# Access Compliance Report

## Public Rights-of-Way

### (Curb Ramps)

Intersection ID: 29504	Main Street: ANTHEM_CT	Cross Street: ROSS_MOORE_AV	Location: E
ADA ID: 87A23976F56E	Ramp Type: PerpDiag	Initial Pass/Fail: Fail	Overall Compliance: No
		Severity Score: 12.5

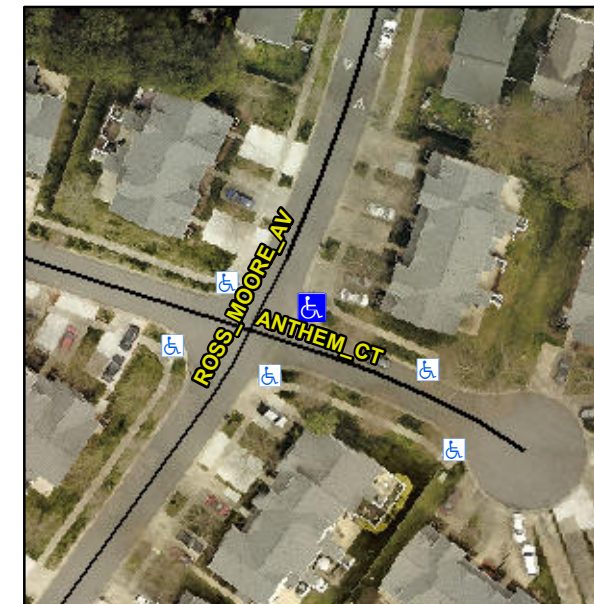
**R304.2.2**

Compliance	Description	Data	Compliance	Description	Data
N/A	Ramp Length (in)	95.0	No	Ramp Slope (%)	8.4
Yes	Ramp Width (in)	48.0	Yes	Ramp XSlope (%)	0.9
N/A	Flare Type LT	N/A	N/A	Flare Type RT	N/A
N/A	Flare Slope LT (%)	N/A	N/A	Flare Slope RT (%)	N/A
N/A	Flare Traversable LT?	N/A	N/A	Flare Traversable RT?	N/A
N/A	Landing Length (in)	N/A	N/A	DWS Provided?	N/A
N/A	Landing Width (in)	N/A	N/A	DWS Contrast?	N/A
N/A	Landing Slope (%)	N/A	N/A	DWS Length (in)	N/A
N/A	Landing X Slope (%)	N/A	N/A	DWS Full Width?	N/A
N/A	Landing Curb? (Y/N)	N/A	N/A	DWS Offset (in)	N/A
N/A	Shared Landing?	N/A			
N/A	Gutter Ponding?	N/A	N/A	Gutter Slope (%)	N/A
N/A	Gutter Lip Ht (in)	N/A	N/A	Gutter X Slope (%)	N/A
N/A	Painted X Walk1?	No	N/A	Painted X Walk2?	No
	X Walk 1 Direction	To NW		X Walk 2 Direction	To SW
N/A	X Walk 1 Width (in)	N/A	N/A	X Walk 2 Width (in)	N/A
	X Walk 1 Slope (%)	0.1		X Walk 2 Slope (%)	1.7
	X Walk 1 X Slope (%)	1.9		X Walk 2 X Slope (%)	1.3

**Remove & Replace Curb Ramp With Two New Directional Ramps or Equivalent.**
